# Memorandum

Planning Division  
Community & Economic Development Department

Re: Revisions to Marmalade Lofts Planned Development- 737 South 300 West

Encl: *Exhibit A*: Revised drawings based on June 26 commission discussion

SHEET C-2

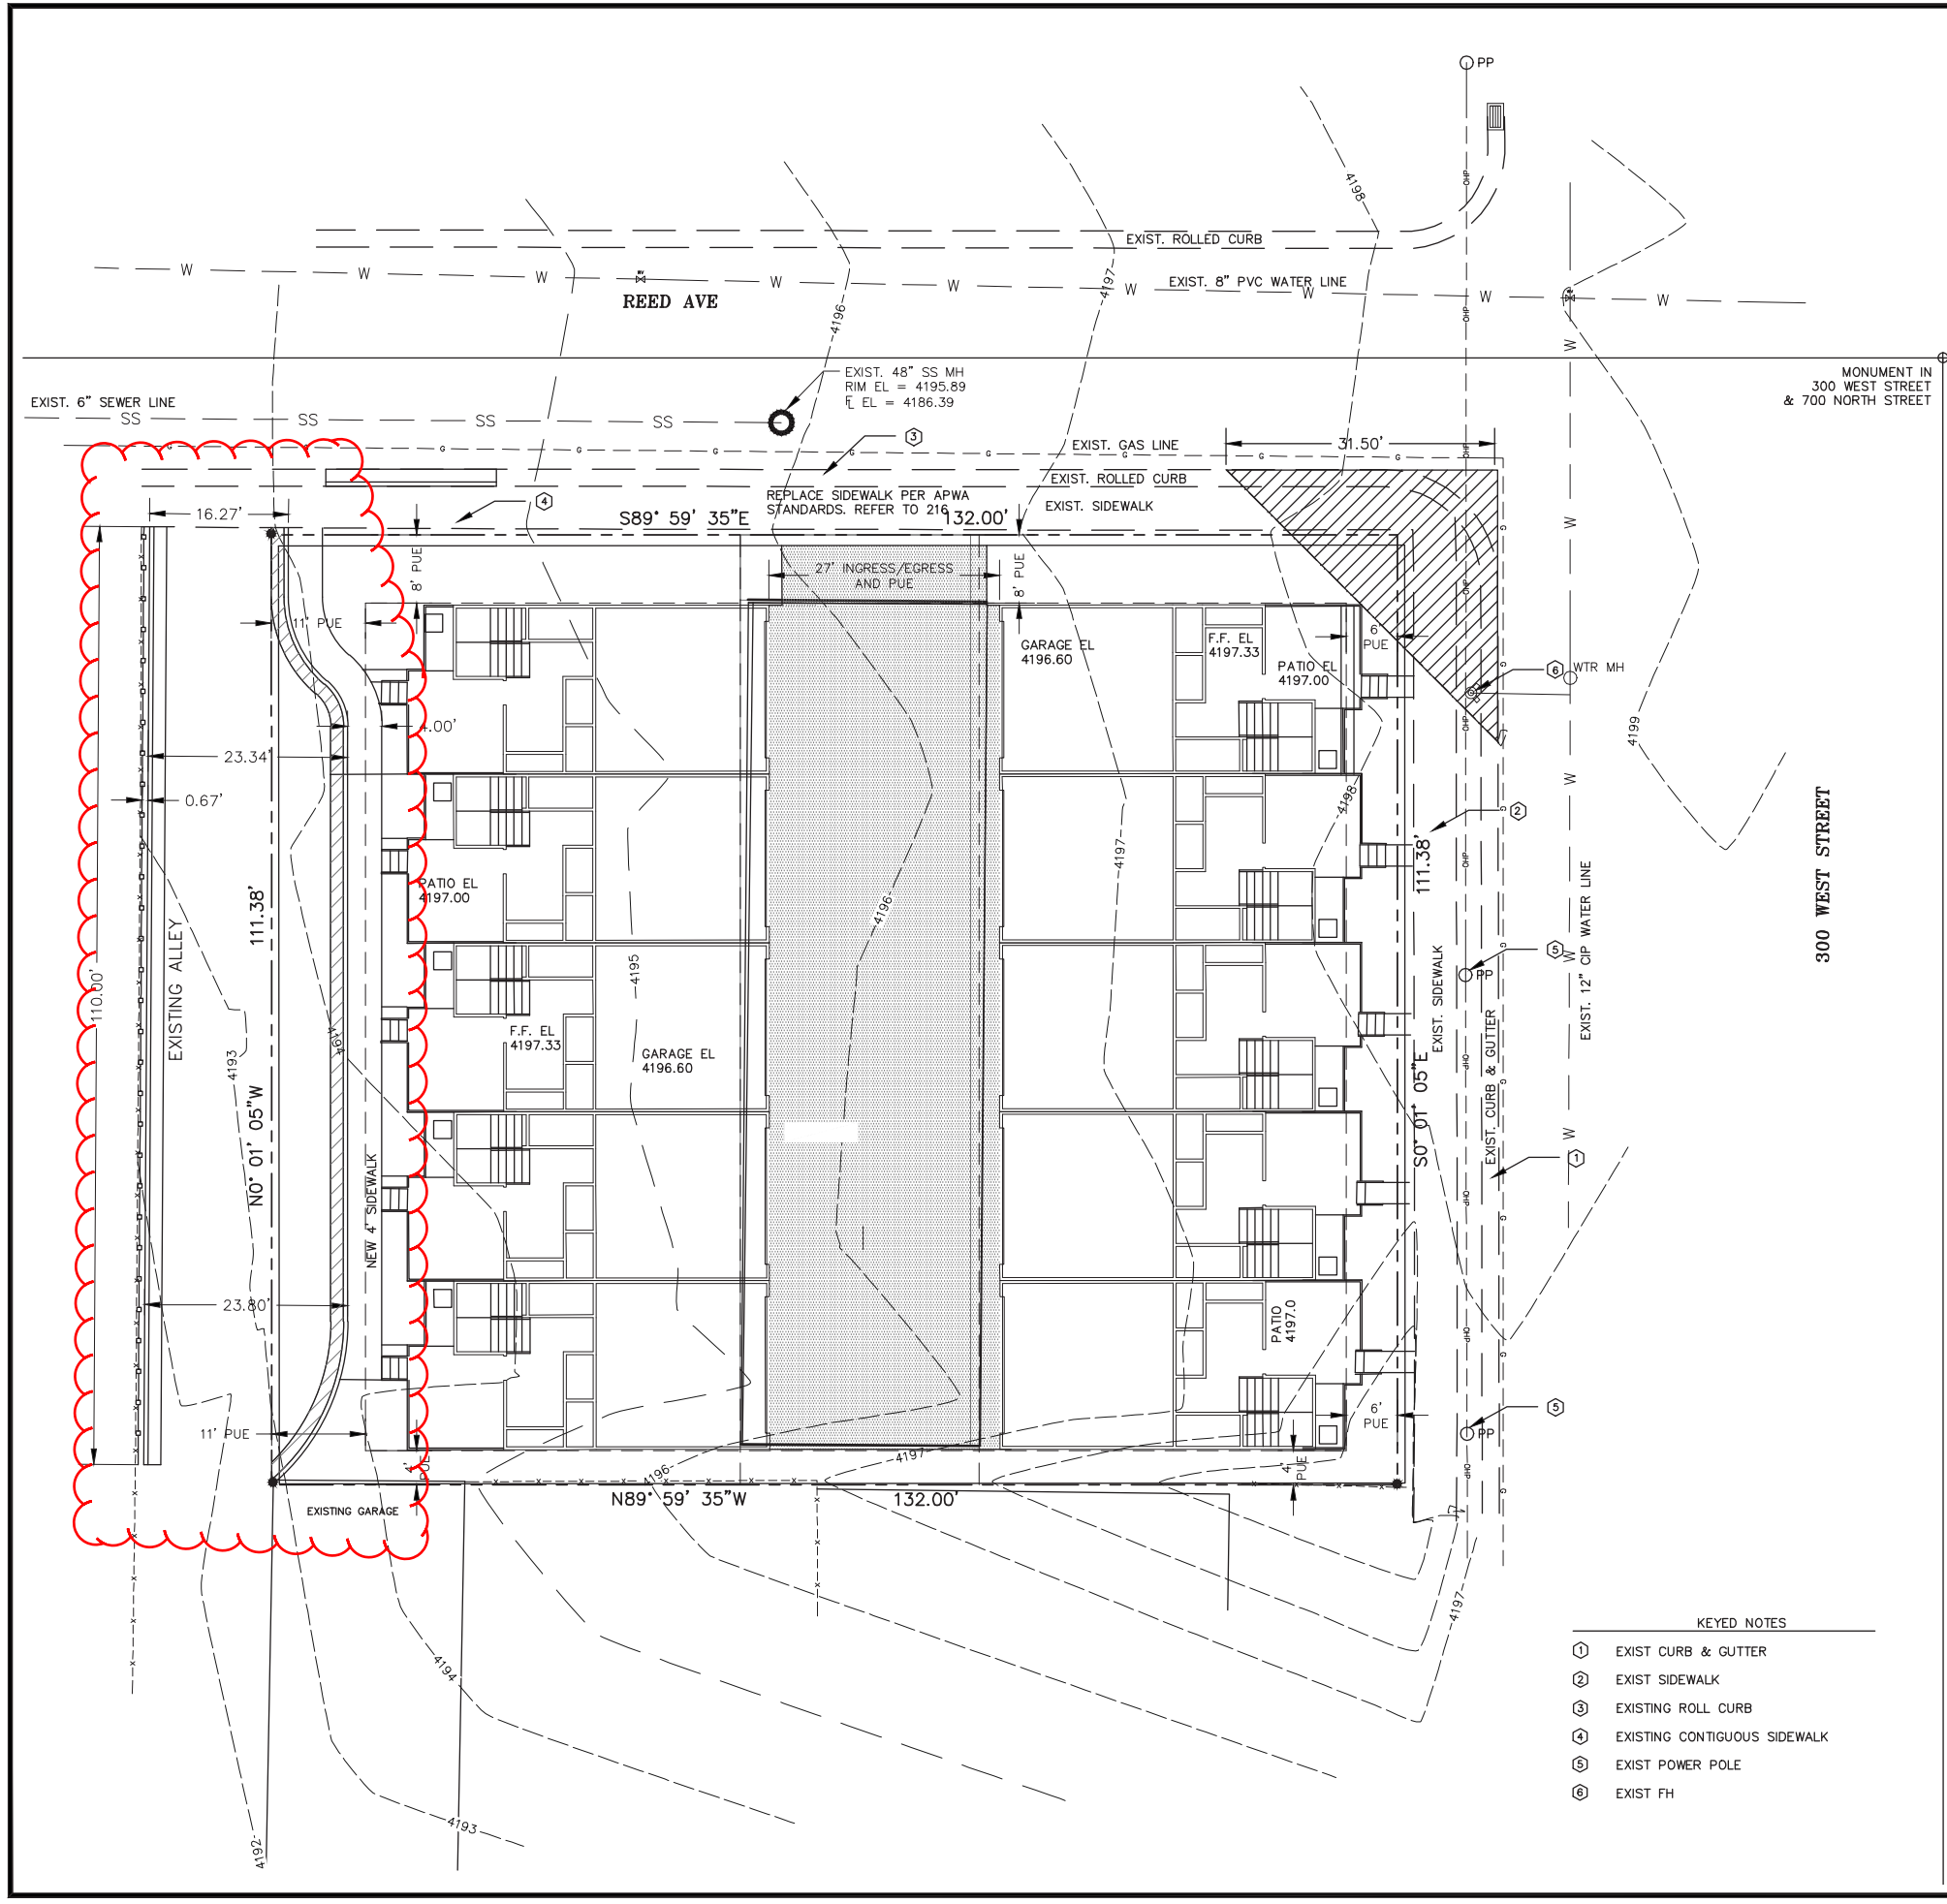
The private alley west and adjacent to the site would be improved with pavement, curb, gutter and sidewalk. The paved area would extend into the subject property with a pull out for vehicles and a sidewalk. The applicant claims this proposal achieves the improved connectivity that the commission sought. It provides vehicle and pedestrian activity on that side of the property by allowing for vehicle parking in front of the west units and creates a usable street that was not there before.

This proposal comes at the expense of open space and landscaped area, and leaves unanswered the question of “who” and “how” the alley and improvements will be maintained in the future. The question also arises as to who gives permission to pave the alley – the applicant does not own it. Since the alley is not public, nor owned by the city, the city has no obligation to maintain the alley and the applicant has not provided a method for maintenance at this time.

The proposal involves paving/improving only the portion of the alley adjacent to the project. The result is an alley that is partially improved and then ends abruptly once past the project. It is unclear how the alley would be signed for vehicle circulation and how vehicles would enter and exit the property from the alley.

The MU zoning district requires a minimum open space total of 20% of the lot area. The original proposal barely met that threshold and with the reduction in open space due to the additional paving, the project would drop below 20%. The commission would have to waive that requirement as part of the planned development approval.

It is staff’s opinion that the reduced landscaping and open space weakens the project’s adherence to the planned development purpose of “*use of design, landscape or architectural features to create a pleasing environment*”, which was the key purpose under which the original site design demonstrated compliance with the purposes for planned developments in the city.

The paved alley and vehicle pullout create a sense of a front yard area for the west units. The definition of front yard involves fronting a public street and the alley is not a “public” street. For discussion of setbacks, four of the western lots do not have frontage on a public street, which was one of the original reasons the applicant sought planned development approval. With the proposed alley improvement, the west edge of the development could be considered the front for setback purposes, and the rear yard would then be that area occupied by the common drive down the middle of the project. Setbacks were, and continue to be, the second reason the applicant sought planned development approval. The planning commission indicated in its vote to table the item its willingness to modify setbacks if that would facilitate connection to the street.

The proposed improvements to the private alley give, in a practical sense -but not technically, a street frontage to those four lots that would not have direct access to a public street. Although the public street frontage requirement would still have to be waived for this planned development, it may be easier to do so because of the proposed alley access.

The commission included, in the motion to table, a condition for a “joint recycling” facility for the development. The applicant’s revised plans do not indicate a recycling facility as part of the project.
